AGENDA
FARRAGUT MUNICIPAL PLANNING COMMISSION

February 15, 2018
7:00 p.m. Farragut Town Hall

SUBJECT: Discussion and public hearing on a request for approval of a site plan for the BKW Restaurant, 12802 Kingston Pike, 1.34 Acres, Zoned C-1 (GBS Engineering, Applicant)

**SUBJECT: STAFF COMMENTS ON THE SITE PLAN FOR THE BKW
RESTAURANT PROPOSED AT 12802 KINGSTON PIKE**

Site Development Plans for *New Restaurant*

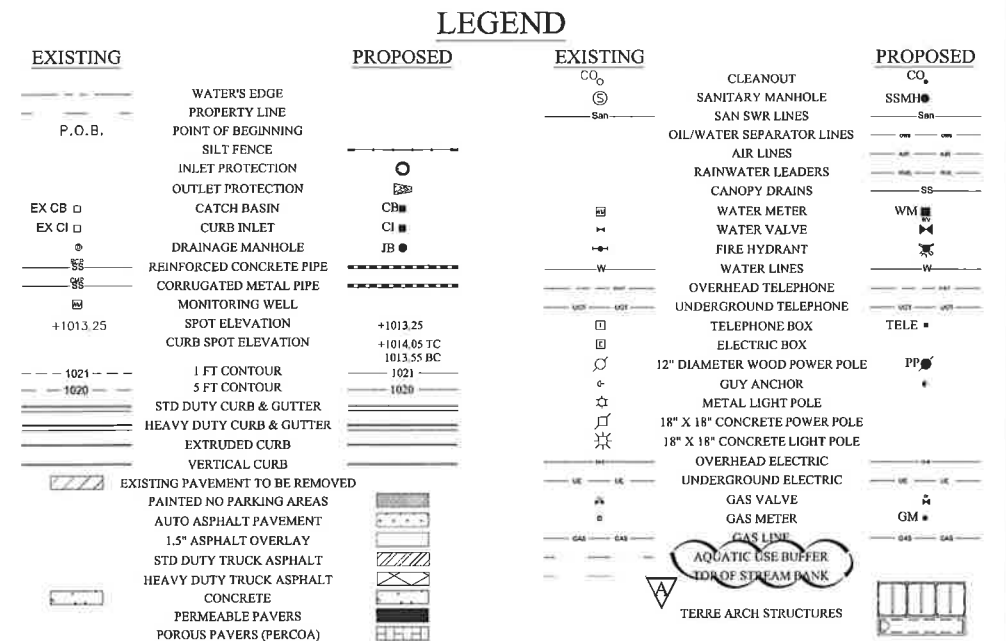
- 27) Cover sheet: the word "aquatic" is misspelled in the legend;

18. We have revised the Coverage Calculations to reflect Lot Coverage as requested, see drawing C3.1.
19. We will be presenting to VRRB this month.
20. We state this requirement in the Notes on the Cover Sheet.

WEST ELEVATION
SCALE 1/8"=1'-0"

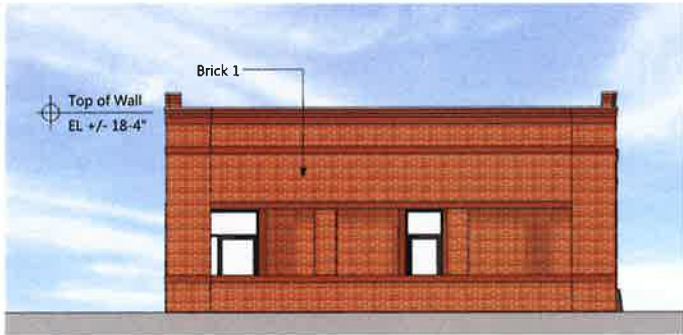
- 11) The building elevations do not include color information. The applicant also needs to submit a full ADS checklist;
- 12) Please detail an ADA compliant sidewalk/curb ramp at the Kingston Pike/entrance road corner;

11. We plotted the elevations in color as part of this submittal. Also, attached is the completed ADS Checklist.
12. We have labeled the existing handicap ramp, see drawing C3.0.

SITE LANDSCAPE PLAN

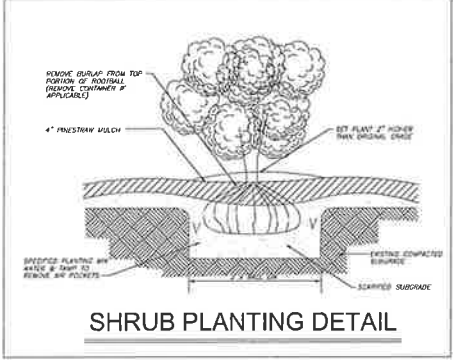
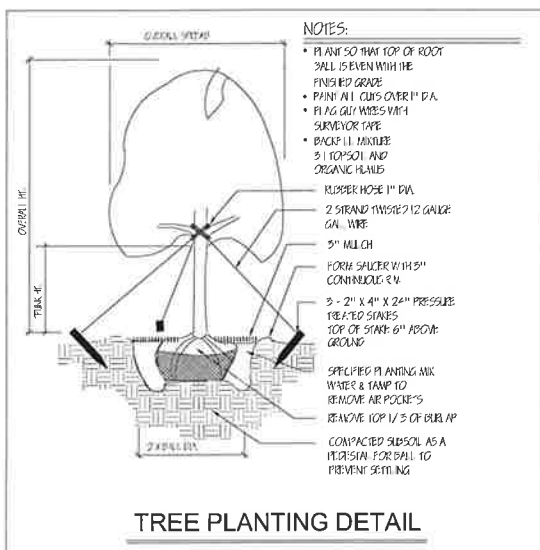
- 19) The landscape plan will be reviewed by the VRRB and requires a separate application. A grading permit cannot be issued until the landscape plan is approved;
